**ADDENDUM
NO. 1**

March 3, 2021

Scott County School District 1 – Austin Elementary Additions & Renovations and HS Pool Renovation
Austin, IN 47102

ADDENDUM NO. ONE

DETAIL 903 - RIP RAP APRON DETAIL
NOT TO SCALE

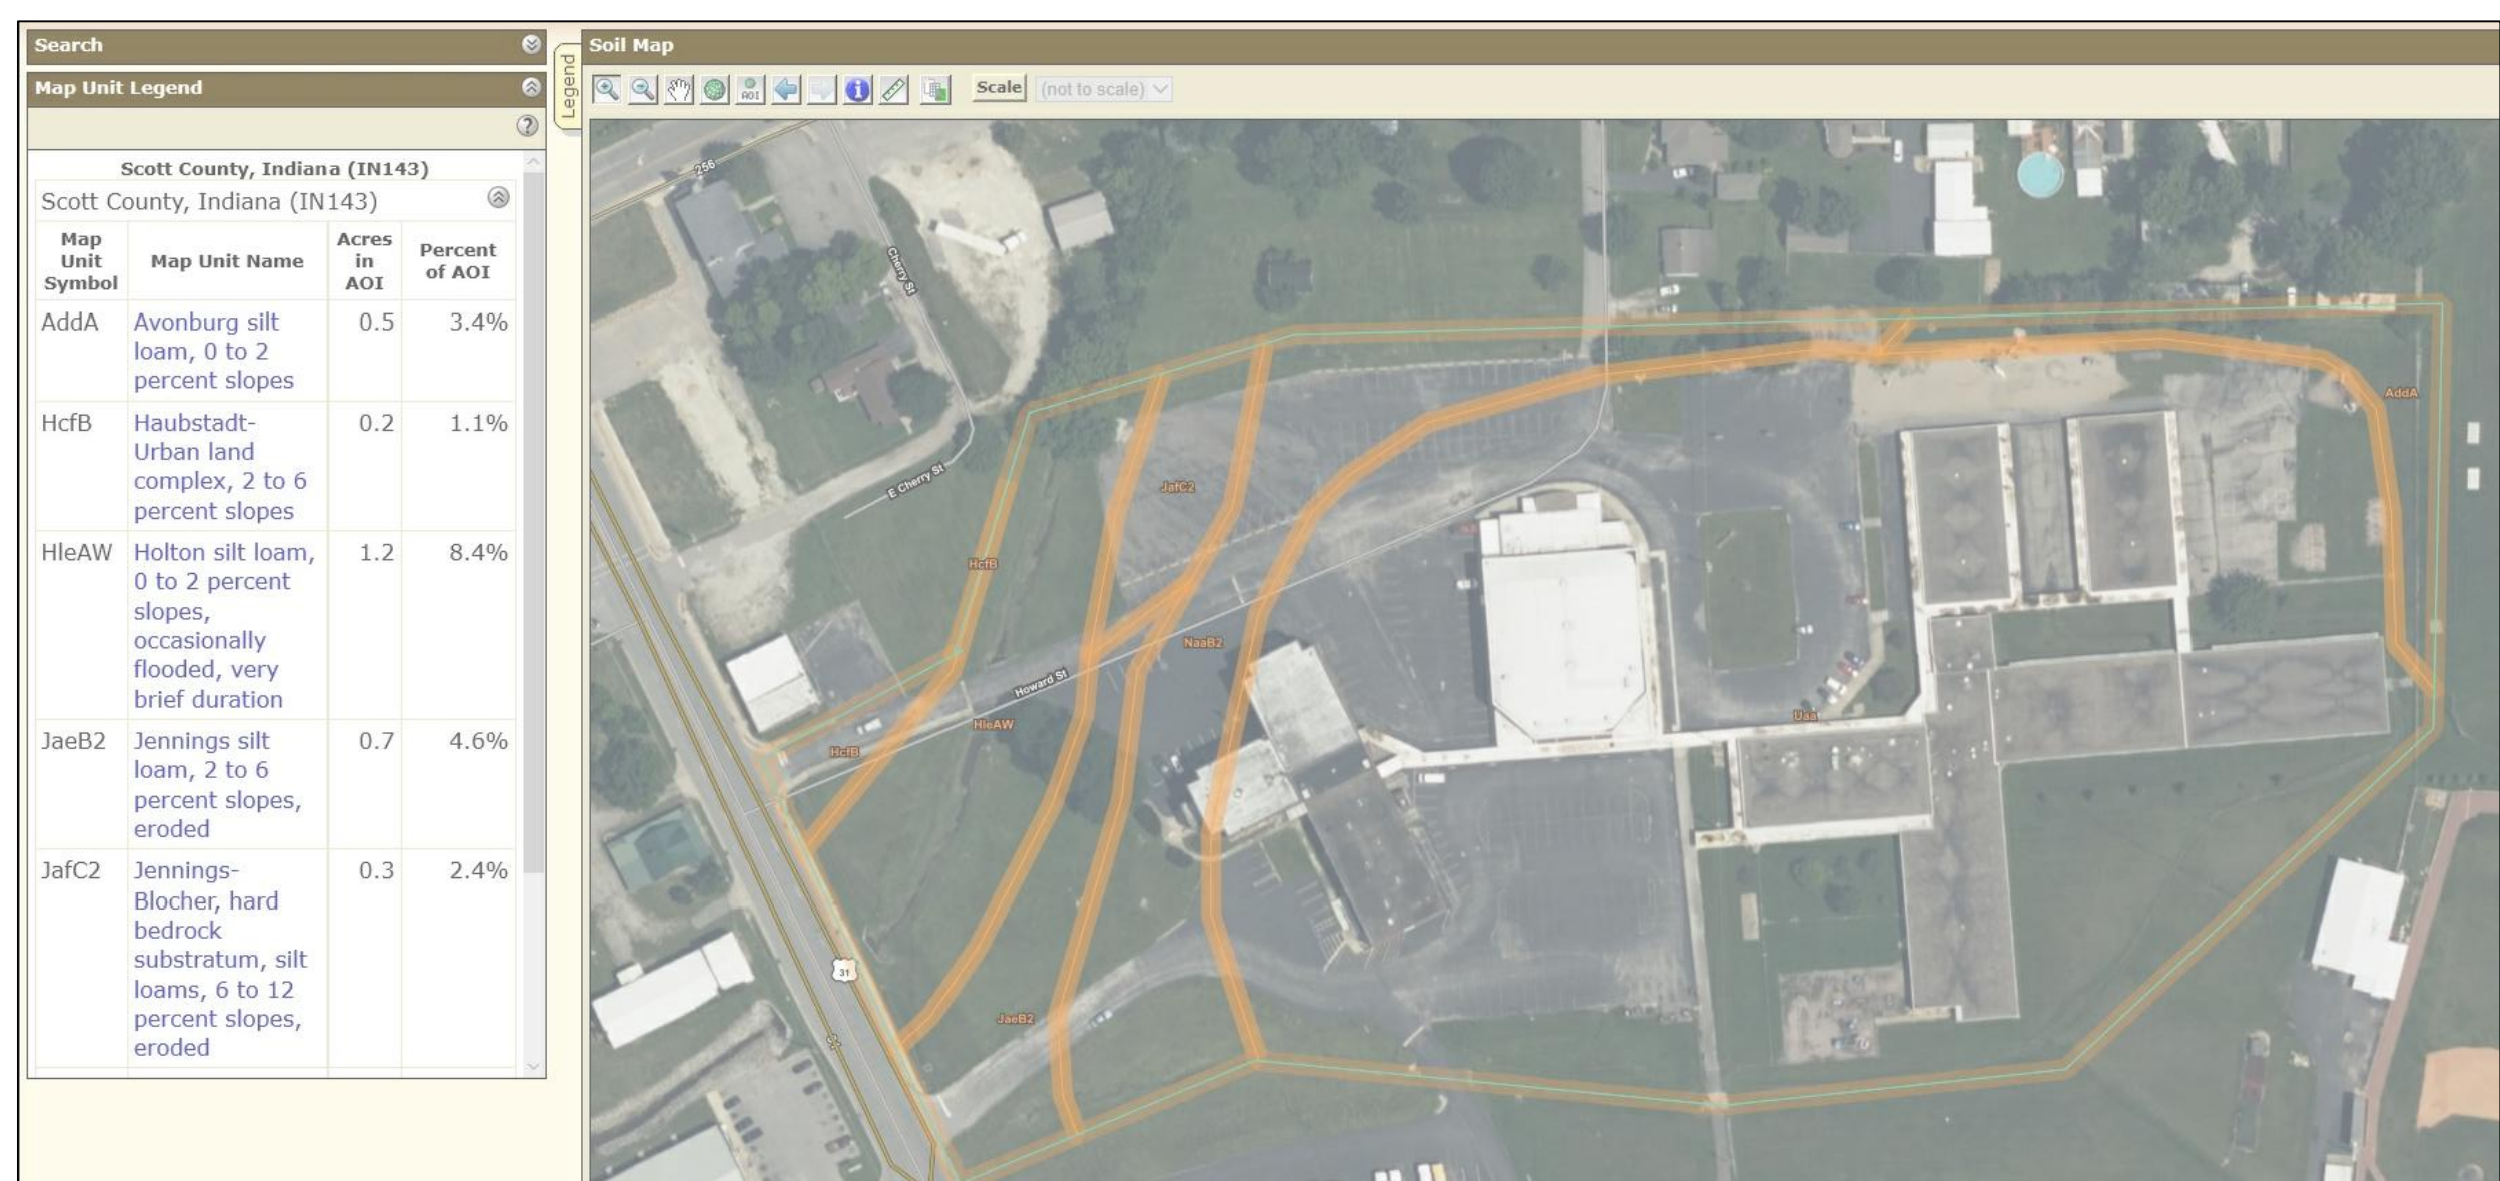
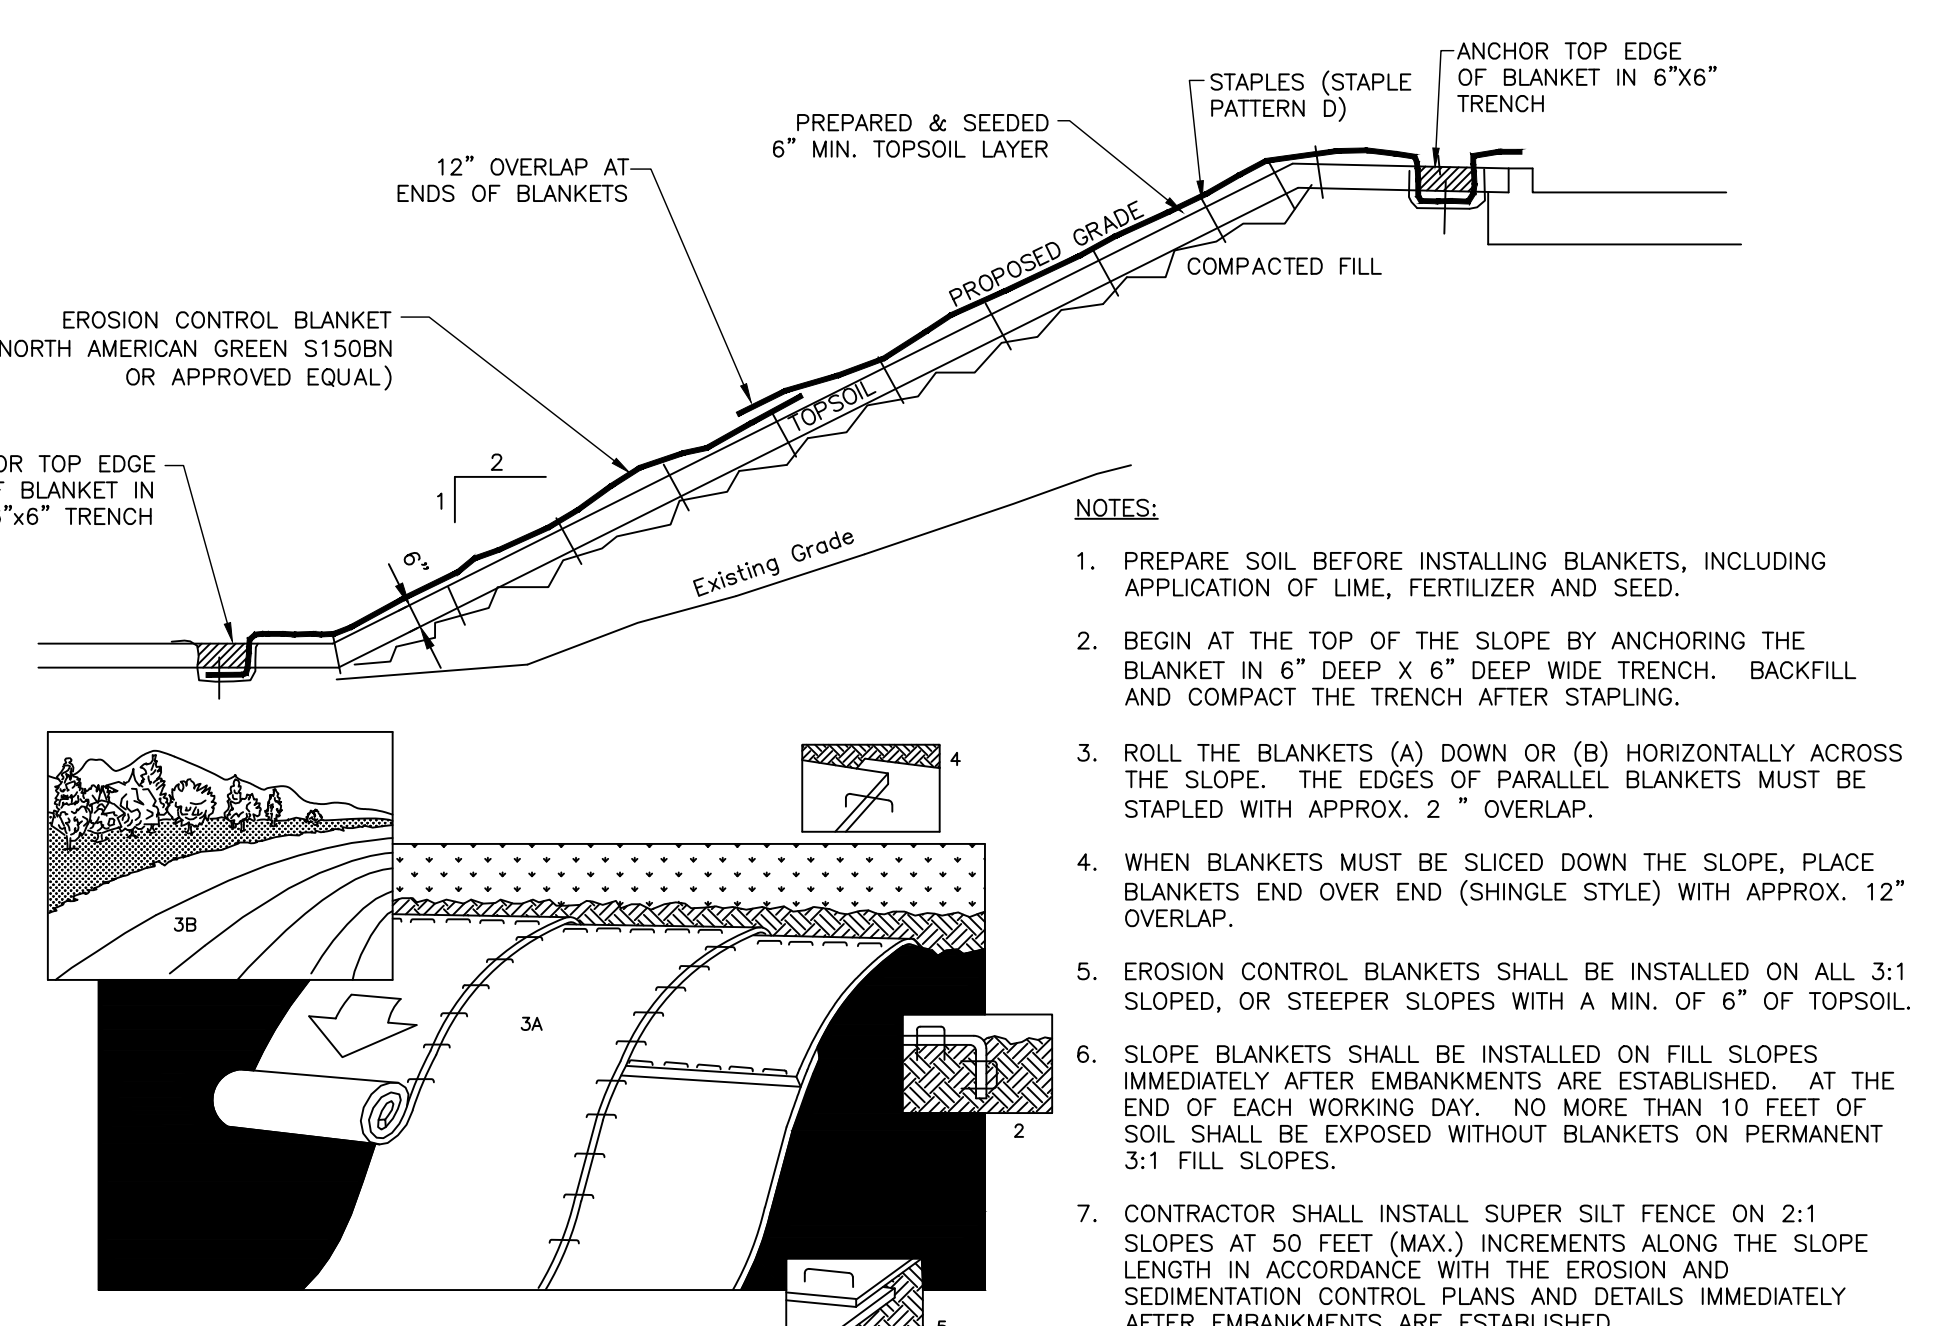
Added Rip Rap apron to Structure 416 end section

Revised Detail 903 table to show correct Structure numbers, added information for Structure 416, and revised depth information for Structure 400
